DOCUMENT 00 91 13

ADDENDUM 2

WILSON APARTMENTS
ELECTRICAL EQUIPMENT REPLACEMENT
ST. CLOUD HOUSING & REDEVELOPMENT AUTHORITY (HRA)
ST. CLOUD, MINNESOTA

July 9, 2026

SHEET NUMBER
E301

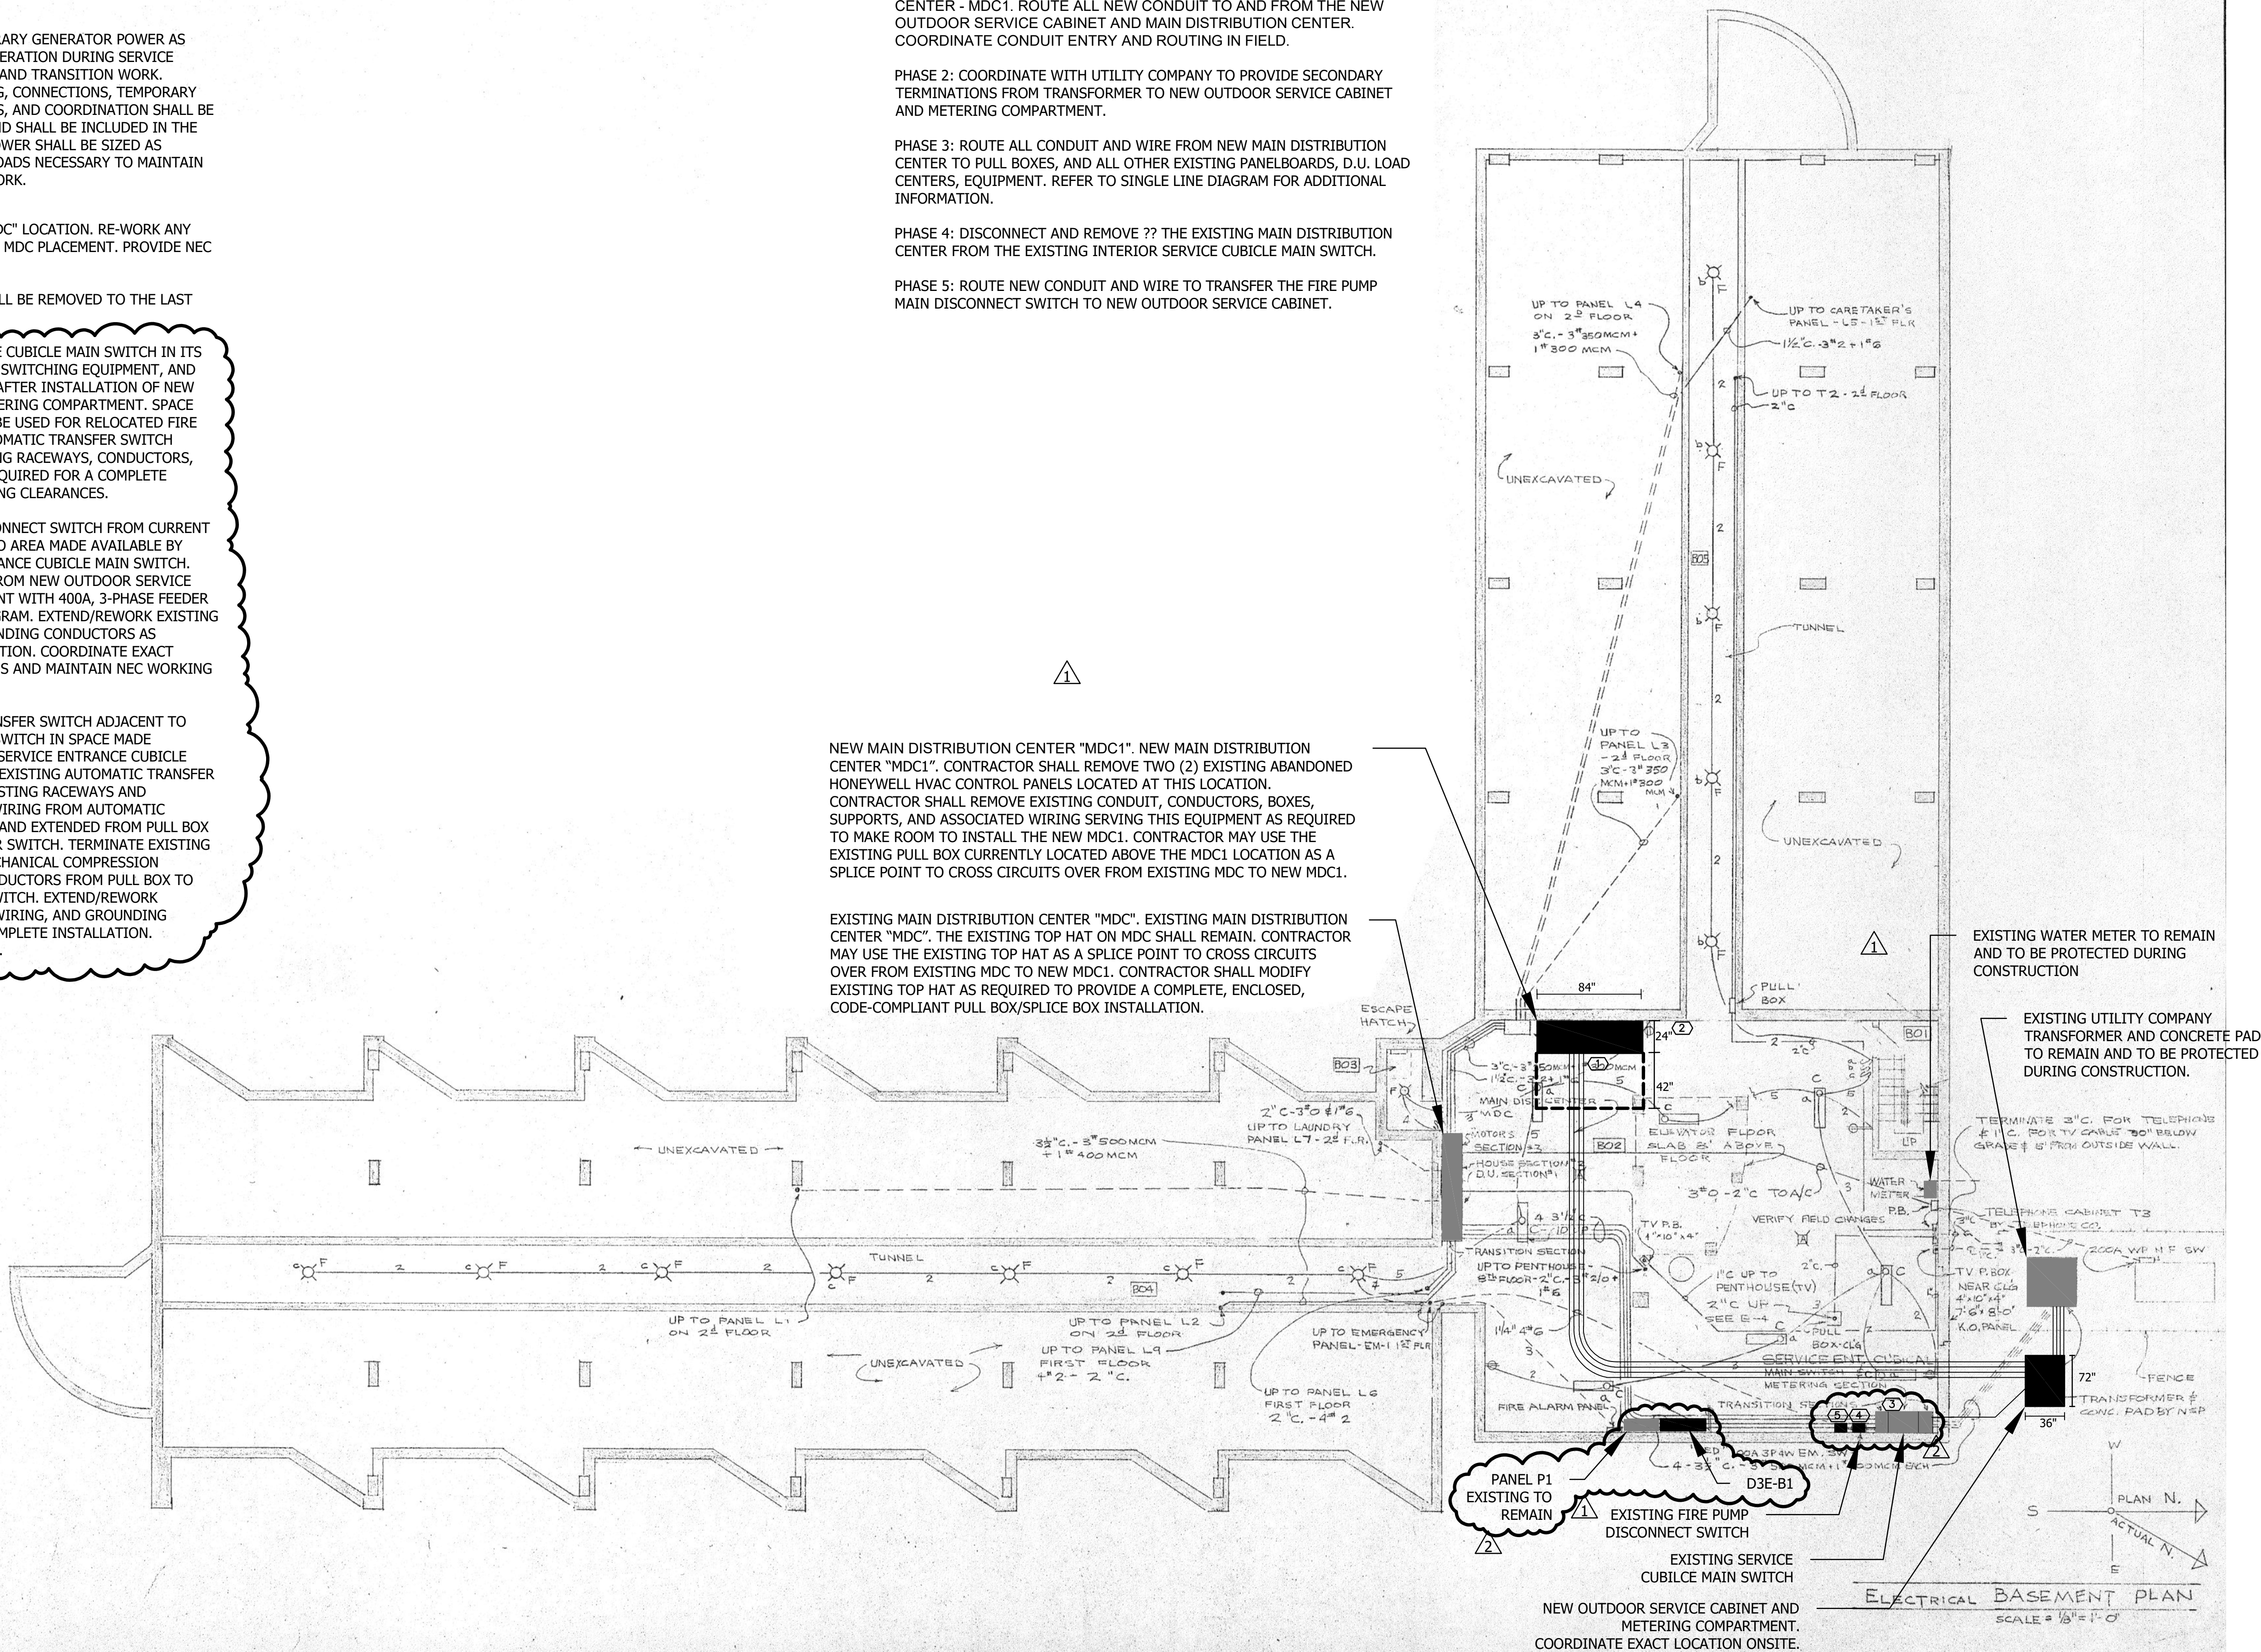
1. Add keyed note 3 with the following:

REMOVE EXISTING SERVICE ENTRANCE CUBICLE MAIN SWITCH IN ITS ENTIRETY. REMOVE ASSOCIATED BUS, SWITCHING EQUIPMENT, AND COMPONENTS NO LONGER REQUIRED AFTER INSTALLATION OF NEW OUTDOOR SERVICE CABINET AND METERING COMPARTMENT. SPACE MADE AVAILABLE BY REMOVAL SHALL BE USED FOR RELOCATED FIRE PUMP DISCONNECT SWITCH AND AUTOMATIC TRANSFER SWITCH EQUIPMENT. EXTEND/REWORK EXISTING RACEWAYS, CONDUCTORS, AND GROUNDING CONDUCTORS AS REQUIRED FOR A COMPLETE INSTALLATION. MAINTAIN NEC WORKING CLEARANCES.

2. Add keyed note 4 with the following:

RELOCATE EXISTING FIRE PUMP DISCONNECT SWITCH FROM CURRENT LOCATION BELOW SANITARY PIPING TO AREA MADE AVAILABLE BY REMOVAL OF EXISTING SERVICE ENTRANCE CUBICLE MAIN SWITCH. DISCONNECT SWITCH SHALL BE FED FROM NEW OUTDOOR SERVICE CABINET AND METERING COMPARTMENT WITH 400A, 3-PHASE FEEDER AS INDICATED ON THE ONE-LINE DIAGRAM. EXTEND/REWORK EXISTING RACEWAYS, CONDUCTORS, AND GROUNDING CONDUCTORS AS REQUIRED FOR A COMPLETE INSTALLATION. COORDINATE EXACT LOCATION WITH EXISTING CONDITIONS AND MAINTAIN NEC WORKING CLEARANCES.

3. Add keyed note 5 with the following:

RELOCATE EXISTING AUTOMATIC TRANSFER SWITCH ADJACENT TO RELOCATED FIRE PUMP DISCONNECT SWITCH IN SPACE MADE AVAILABLE BY REMOVAL OF EXISTING SERVICE ENTRANCE CUBICLE MAIN SWITCH. PROVIDE PULL BOX AT EXISTING AUTOMATIC TRANSFER SWITCH LOCATION TO INTERCEPT EXISTING RACEWAYS AND CONDUCTORS. EXISTING LOAD-SIDE WIRING FROM AUTOMATIC TRANSFER SWITCH SHALL BE REUSED AND EXTENDED FROM PULL BOX TO RELOCATED AUTOMATIC TRANSFER SWITCH. TERMINATE EXISTING CONDUCTORS IN PULL BOX USING MECHANICAL COMPRESSION CONNECTORS AND PROVIDE NEW CONDUCTORS FROM PULL BOX TO RELOCATED AUTOMATIC TRANSFER SWITCH. EXTEND/REWORK RACEWAYS, CONDUCTORS, CONTROL WIRING, AND GROUNDING CONDUCTORS AS REQUIRED FOR A COMPLETE INSTALLATION. MAINTAIN NEC WORKING CLEARANCES.

4. Electrical Basement Plan:

Add key notes 3, 4, and 5 to the plan view as indicated.

5. Electrical Basement Plan:

Revise note for panel D3E-B1 as indicated.

6. Electrical Basement Plan:

Show existing panel P1 as existing to remain as indicated.

2. EXISTING HVAC CONTROL PANELS SHALL BE REMOVED TO THE LAST ACTIVE JUNCTION BOX.
3. REMOVE EXISTING SERVICE ENTRANCE CUBICLE MAIN SWITCH IN ITS ENTIRETY. REMOVE ASSOCIATED BUS, SWITCHING EQUIPMENT, AND COMPONENTS NO LONGER REQUIRED AFTER INSTALLATION OF NEW OUTDOOR SERVICE CABINET AND METERING COMPARTMENT. SPACE MADE AVAILABLE BY REMOVAL SHALL BE USED FOR RELOCATED FIRE PUMP DISCONNECT SWITCH AND AUTOMATIC TRANSFER SWITCH EQUIPMENT. EXTEND/REWORK EXISTING RACEWAYS, CONDUCTORS, AND GROUNDING CONDUCTORS AS REQUIRED FOR A COMPLETE INSTALLATION. MAINTAIN NEC WORKING CLEARANCES.

4. RELOCATE EXISTING FIRE PUMP DISCONNECT SWITCH FROM CURRENT LOCATION BELOW SANITARY PIPING TO AREA MADE AVAILABLE BY REMOVAL OF EXISTING SERVICE ENTRANCE CUBICLE MAIN SWITCH. DISCONNECT SWITCH SHALL BE FED FROM NEW OUTDOOR SERVICE CABINET AND METERING COMPARTMENT WITH 400A, 3-PHASE FEEDER AS INDICATED ON THE ONE-LINE DIAGRAM. EXTEND/REWORK EXISTING RACEWAYS, CONDUCTORS, AND GROUNDING CONDUCTORS AS REQUIRED FOR A COMPLETE INSTALLATION. COORDINATE EXACT LOCATION WITH EXISTING CONDITIONS AND MAINTAIN NEC WORKING CLEARANCES.

5. RELOCATE EXISTING AUTOMATIC TRANSFER SWITCH ADJACENT TO RELOCATED FIRE PUMP DISCONNECT SWITCH IN SPACE MADE AVAILABLE BY REMOVAL OF EXISTING SERVICE ENTRANCE CUBICLE MAIN SWITCH. PROVIDE PULL BOX AT EXISTING AUTOMATIC TRANSFER SWITCH LOCATION TO INTERCEPT EXISTING RACEWAYS AND CONDUCTORS. EXISTING LOAD-SIDE WIRING FROM AUTOMATIC TRANSFER SWITCH SHALL BE REUSED AND EXTENDED FROM PULL BOX TO RELOCATED AUTOMATIC TRANSFER SWITCH. TERMINATE EXISTING CONDUCTORS IN PULL BOX USING MECHANICAL COMPRESSION CONNECTORS AND PROVIDE NEW CONDUCTORS FROM PULL BOX TO RELOCATED AUTOMATIC TRANSFER SWITCH. EXTEND/REWORK RACEWAYS, CONDUCTORS, CONTROL WIRING, AND GROUNDING CONDUCTORS AS REQUIRED FOR A COMPLETE INSTALLATION. MAINTAIN NEC WORKING CLEARANCES.

Plot Date: 07/09/2026 - 11:16am
Drawing Name: U:\193807451\CAD\Dwg\Plan Sheets\193807451-E501.dwg
Xrefs: 193807451-BRDR

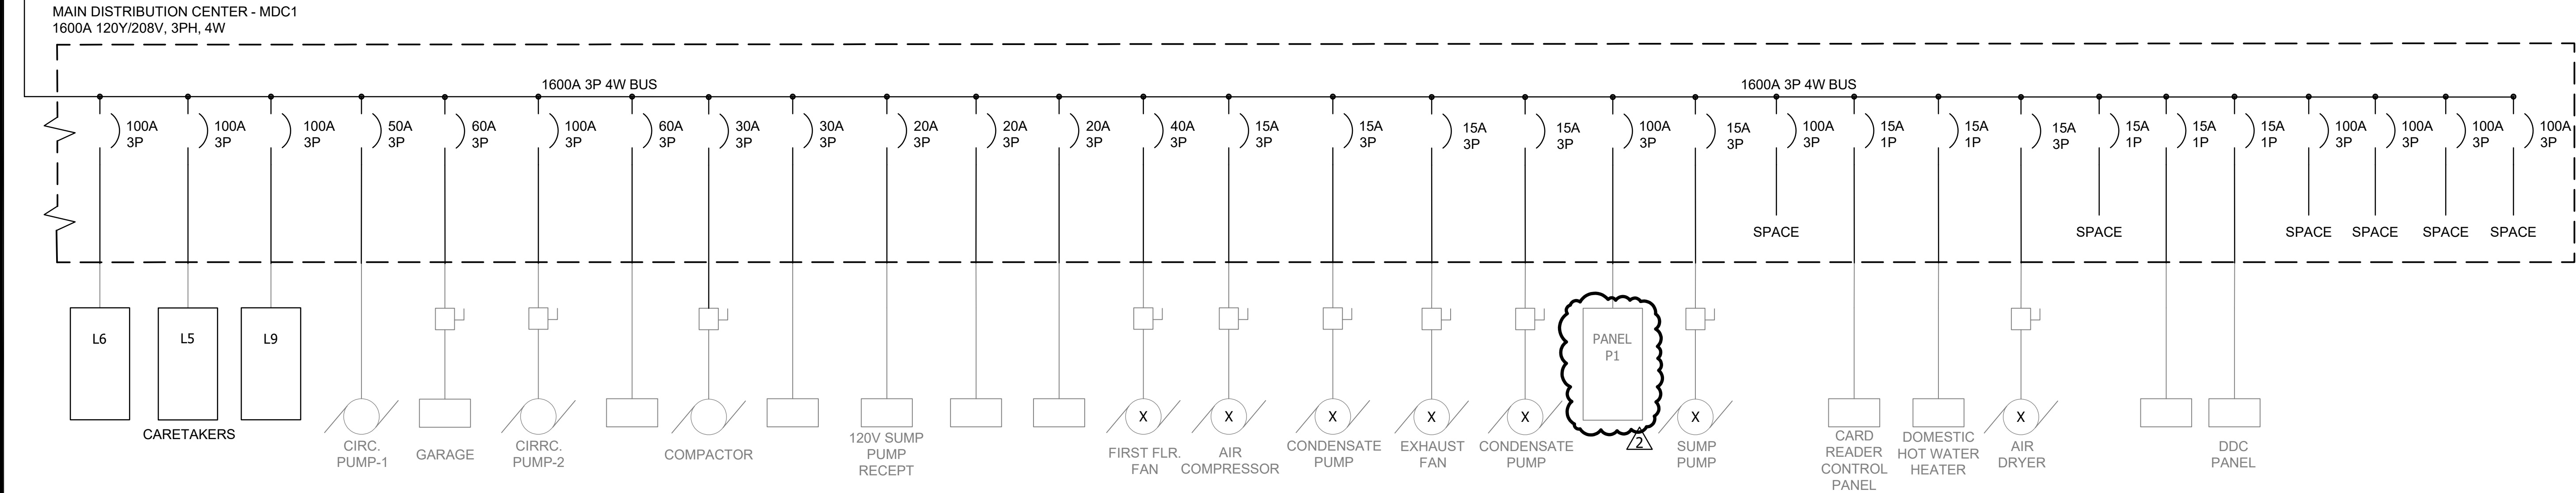
1. Elevator Machine Room:

Revis note for EP1 Panelboard as indicated

A ELECTRICAL ONE LINE DIAGRAM
NO SCALE

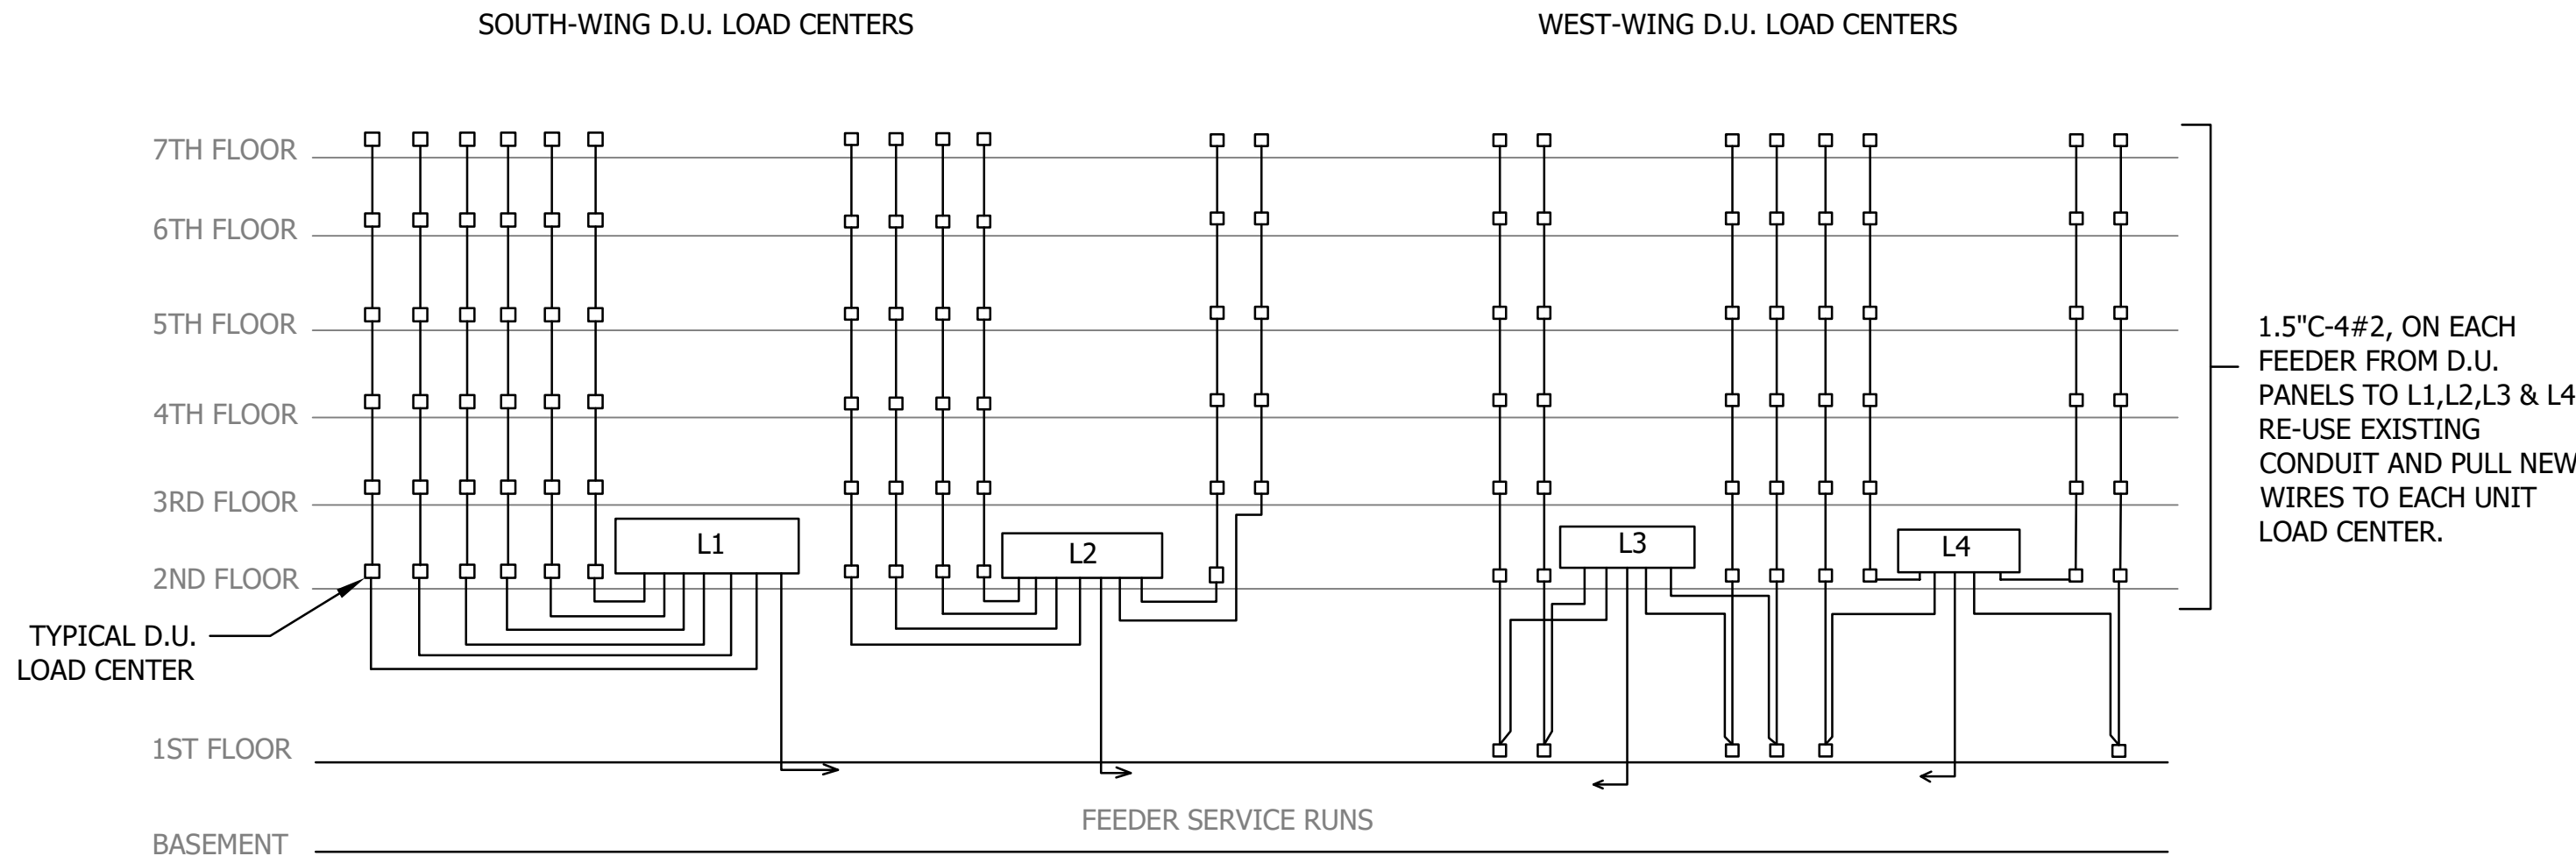
1. Revise Panelboard EP1 as existing to remain as indicated.
2. Revise emergency power switch, ATS, Generator, EM-1 panel and feed to D3E-B1 as indicated.
3. Show existing panel P1 as existing to remain as indicated.
